Changes to proposed District Map Amendment G-956

A revised version of DMA G-956, dated July 11, 2014, has been posted on the Planning Department website for review. It contains all of the proposed and approved changes that have occurred since May 2, 2013. The following document illustrates all of the changes to DMA G-956 since April 2014.

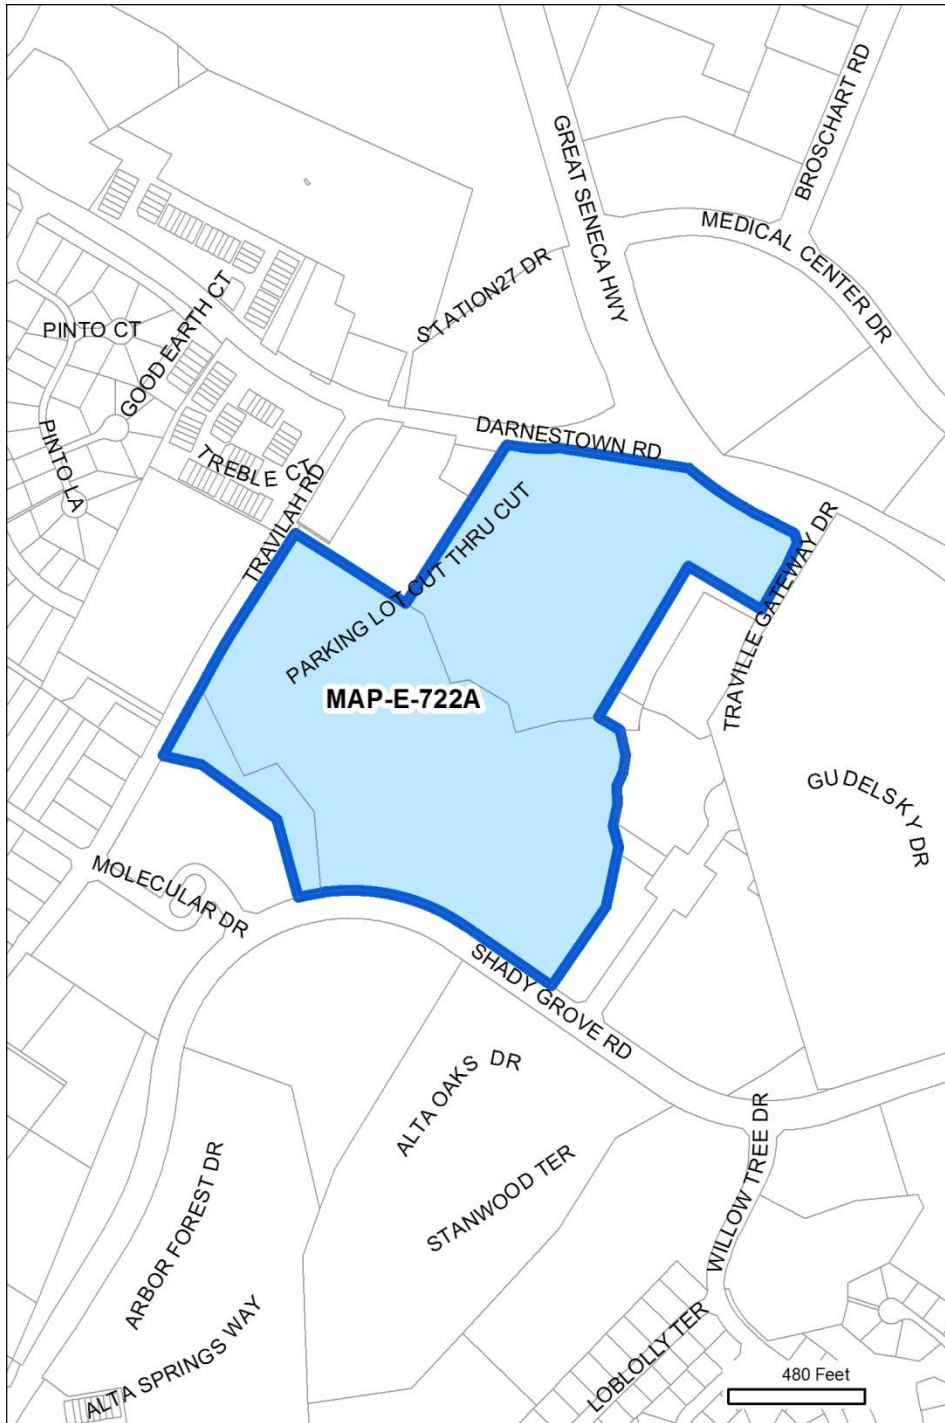
Unique ID: MAP-E-721		staff error
Master Plan ID: WDMNT-12 / WDMNT-06		
Master Plan:	Woodmont Triangle	
Location:	Fairmont Building	
Existing Zone:	CBD-2	
Proposed Conv: (6/2)	CR-5.25 C-5.25 R-4.75 H-145 T	
Prop. Revised Conv:	CR-5.0 C-1.0 R-4.75 H-145 T	
Category:	Error	
Modifications	Zone Group:	No change
	Overall FAR:	Reduced to 5.0
	Comm'l FAR:	Reduced to 1.0
	Resid'l FAR:	No change
	Height:	No change
Reason for change:		
<p><i>This property is located in the CBD-2 zone.</i></p> <p><i>The PHED Committee instructed staff to map Master or Sector Plan recommendations where they existed. However, PHED also instructed staff to map built or approved FAR/height where that density or height was greater than the Master or Sector Plan recommendation.</i></p> <p><i>In this case, the owner of the property requested the density be increased to accommodate the built FAR.</i></p> <p><i>However, in this case, this property was built under the C-2 zone and was made non-conforming many years ago, and therefore the DMA would not change the status of the building.</i></p> <p><i>PHED discussed this situation and determined that where the DMA is not causing a structure to become non-conforming, the built or approved FAR/height should <u>not</u> be mapped.</i></p> <p><i>Therefore, this property is reverting to its conversion under the recommendations set forth in the Woodmont Triangle Plan.</i></p>

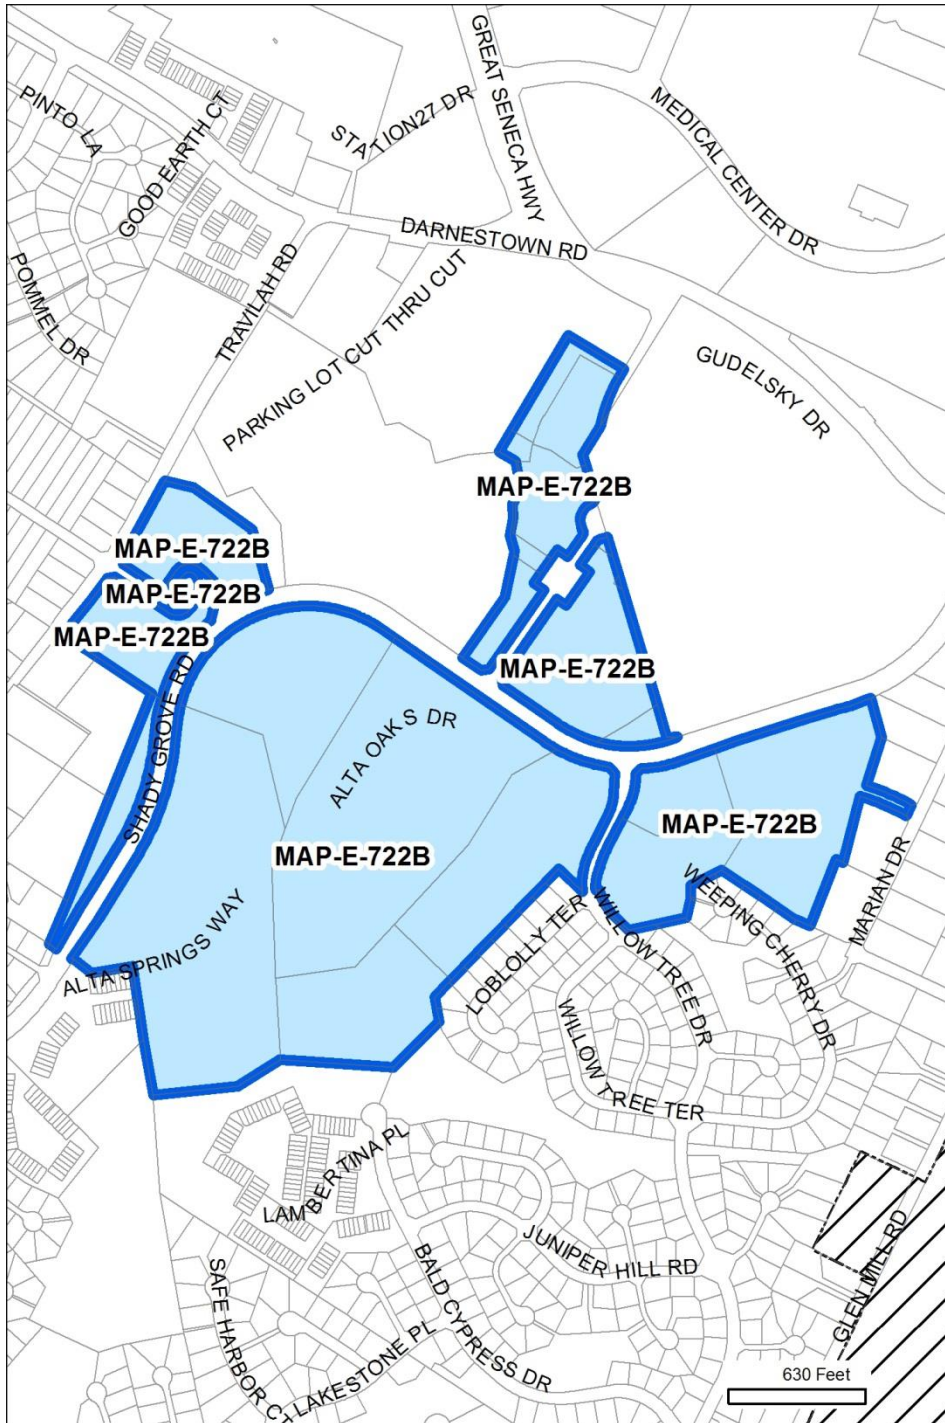
Unique ID: MAP-E-722A		staff error
Master Plan ID: GSSCR-05A		
Master Plan:	Great Seneca Science Corridor	
Location:	Traville Gateway	
Existing Zone:	MXN	
Proposed Conv: (6/2)	CRT-0.5 C-0.5 R-0.25 H-70 T	
Prop. Revised Conv:	CRT-0.5 C-0.5 R-0.25 H-100 T	
Category:	Error	
Modifications	Zone Group:	No change
	Overall FAR:	No change
	Comm'l FAR:	No change
	Resid'l FAR:	No change
	Height:	Increased to 100'
Reason for change:		
<p><i>This property is located in the MXN zone which has no statutory height, but which is a floating zone applied by LMA.</i></p> <p><i>In cases like this, PHED instructed staff to map any approvals made in the LMA application. However, no recommendations regarding height were included in the LMA (and are also not present in the statute).</i></p> <p><i>Staff determined that all site plan approvals would be covered by a mapped height of 70' and that's how the height limit was determined.</i></p> <p><i>However, the owner does not believe the property should be bound by the site plan approvals, since those can be amended at the Planning Board.</i></p> <p><i>Staff agrees, and recommends changing the height to 100', which the owner agrees is sufficient.</i></p>

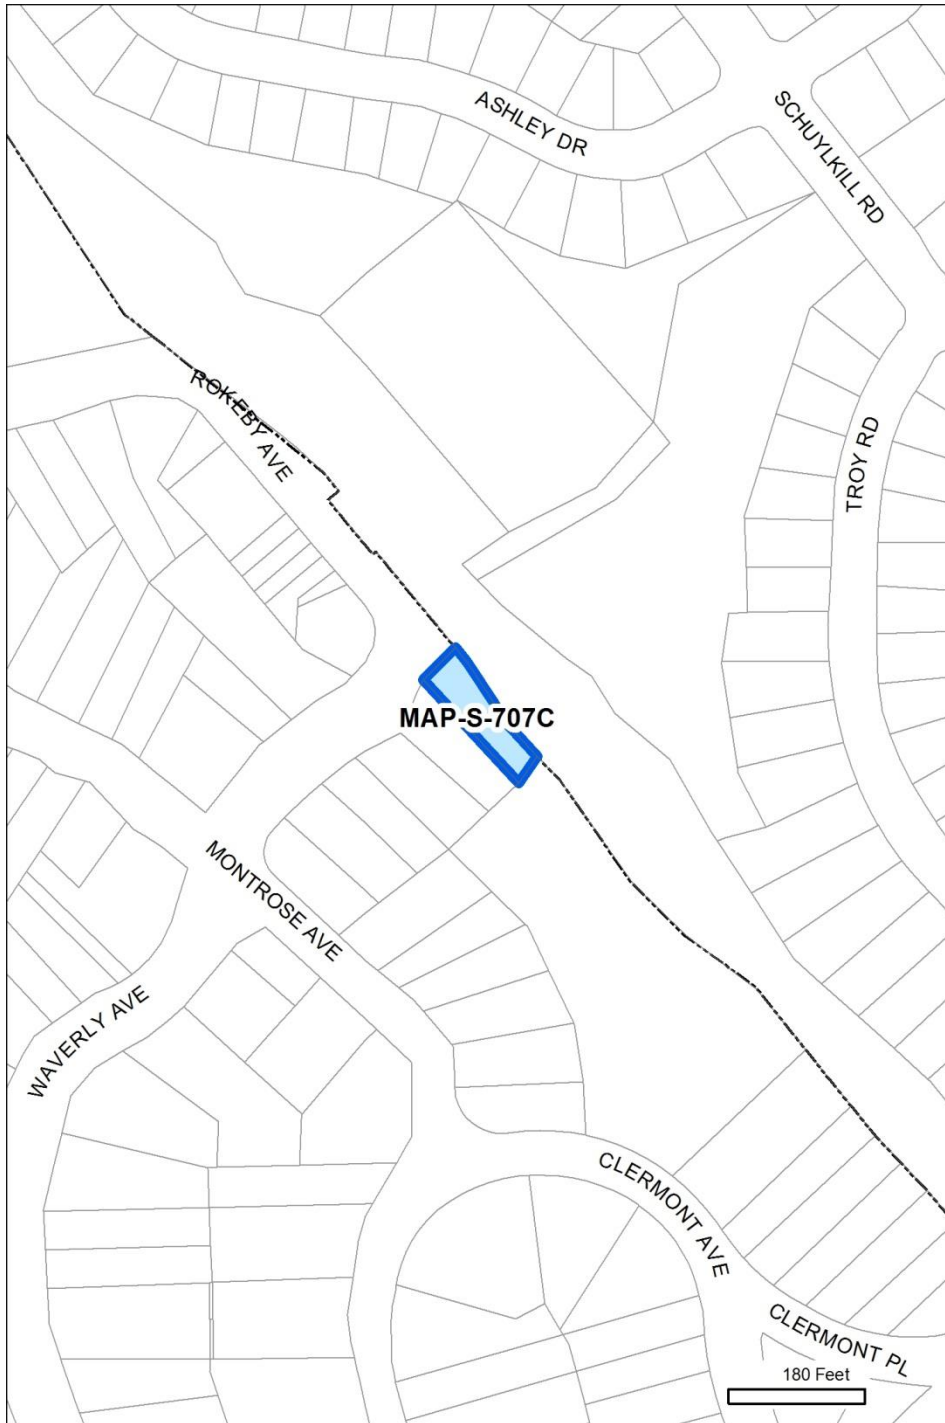
Unique ID: MAP-S-707B		staff change
Master Plan ID: SANDY-04		
Master Plan:	Sandy Spring / Ashton	
Location:	Sandy Spring	
Existing Zone:	C-1	
Proposed Conv: (6/2)	CRT-1.0 C-0.75 R-0.5 H-35	
Prop. Revised Conv:	NR-0.75 H-30	
Category:	Recommended Change	
Modifications	Zone Group:	Changed to NR
	Overall FAR:	Reduced to 0.75
	Comm'l FAR:	-
	Resid'l FAR:	-
	Height:	No change
Reason for change:		
<p><i>These properties are zoned C-1 and are in a Master Plan designated historic district.</i></p> <p><i>Staff recommended changing the "standard" conversion for C-1 in a historic district to NR-0.75 H-45.</i></p> <p><i>However, the Sandy Spring/Ashton Rural Village Overlay limits height in the historic district to 30'.</i></p> <p><i>Therefore, the new conversion is to NR-0.75 H-30.</i></p>

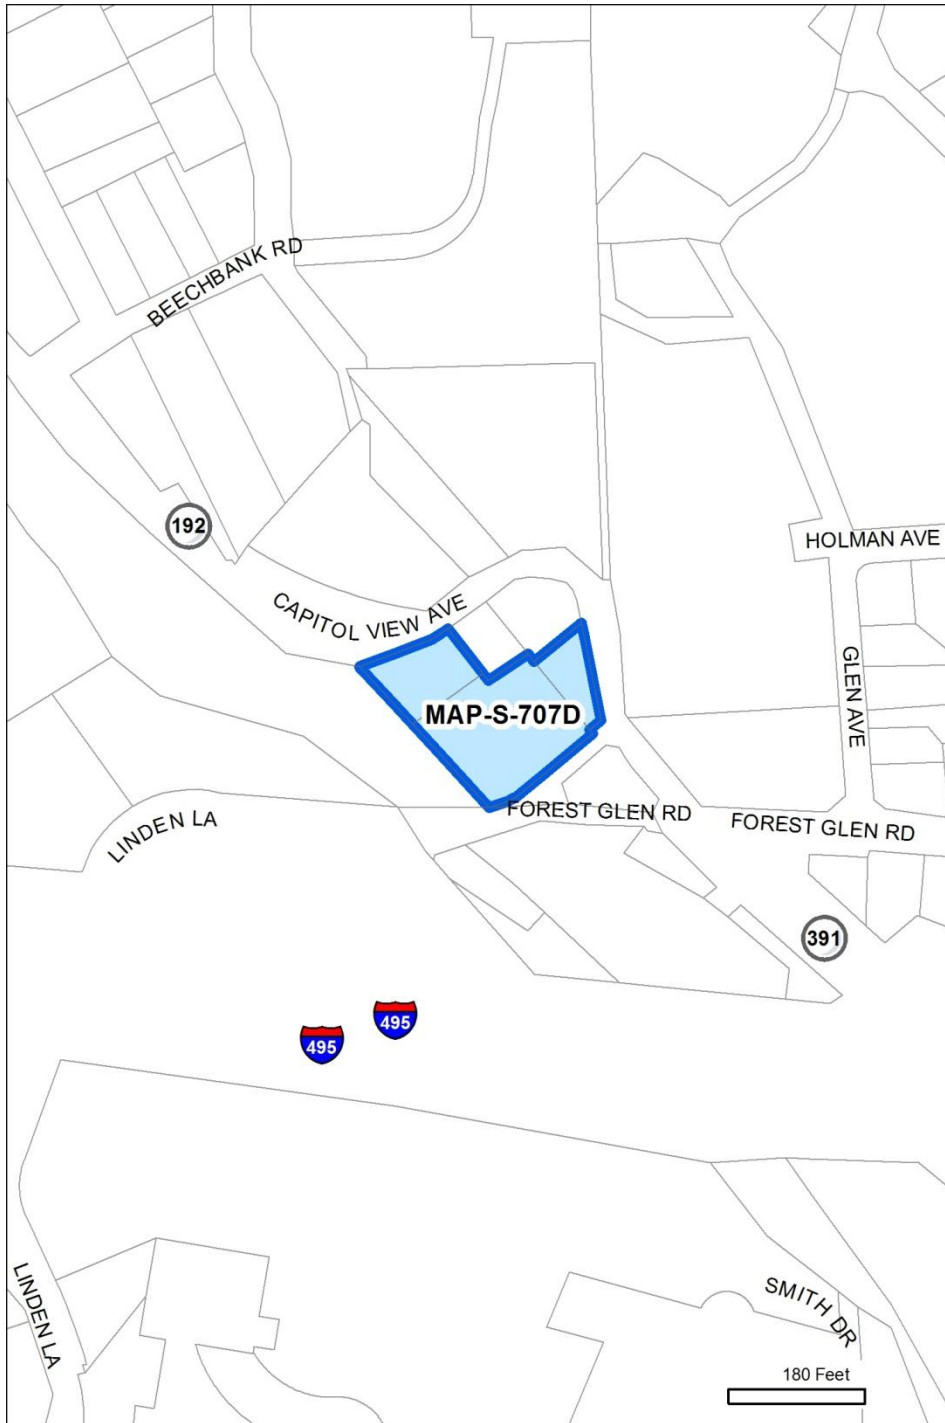
Unique ID: MAP-S-707C		staff change
Master Plan ID:		
Master Plan:	North Bethesda / Garrett Park	
Location:	Garrett Park train station	
Existing Zone:	C-1	
Proposed Conv: (6/2)	CRT-0.5 C-0.5 R-0.25 H-35	
Prop. Revised Conv:	NR-0.75 H-45	
Category:	Recommended Change	
Modifications	Zone Group:	Changed to NR
	Overall FAR:	Increased to 0.75
	Comm'l FAR:	-
	Resid'l FAR:	-
	Height:	No change
Reason for change:		
<p><i>This property is zoned C-1 and are in a Master Plan designated historic district.</i></p> <p><i>Staff recommended changing the "standard" conversion for C-1 in a historic district to NR-0.75 H-45.</i></p>

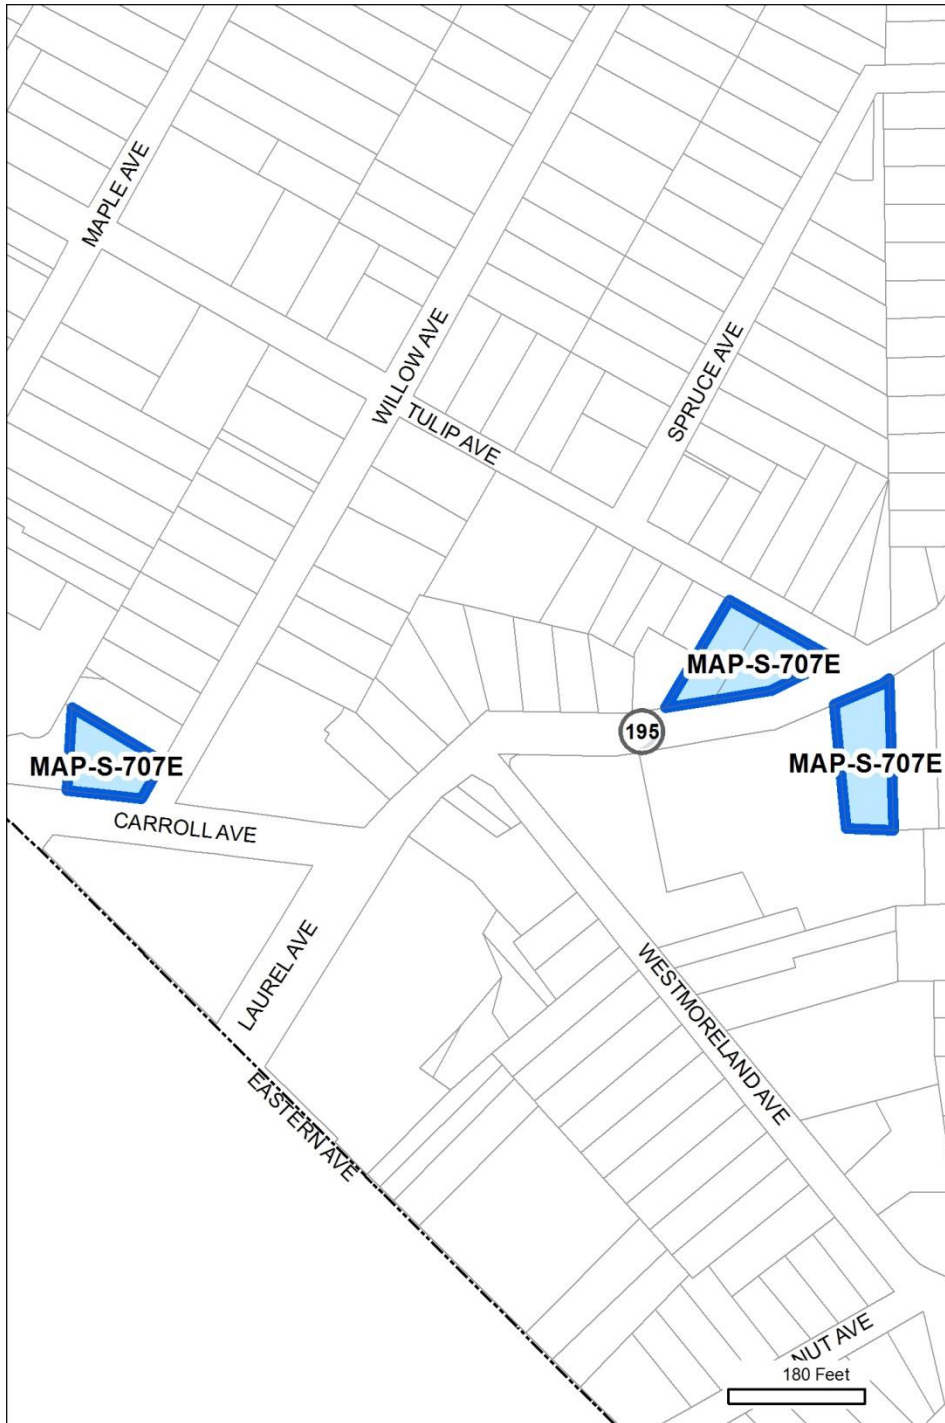
Unique ID: MAP-S-707D		staff change
Master Plan ID:		
Master Plan:	Capitol View	
Location:	Forest Glen Rd & Capitol View Av	
Existing Zone:	C-1	
Proposed Conv: (6/2)	CRT-0.5 C-0.5 R-0.25 H-35	
Prop. Revised Conv:	NR-0.75 H-45	
Category:	Recommended Change	
Modifications	Zone Group:	Changed to NR
	Overall FAR:	Increased to 0.75
	Comm'l FAR:	-
	Resid'l FAR:	-
	Height:	No change
Reason for change:		
<p><i>This property is zoned C-1 and are in a Master Plan designated historic district.</i></p> <p><i>Staff recommended changing the "standard" conversion for C-1 in a historic district to NR-0.75 H-45.</i></p>
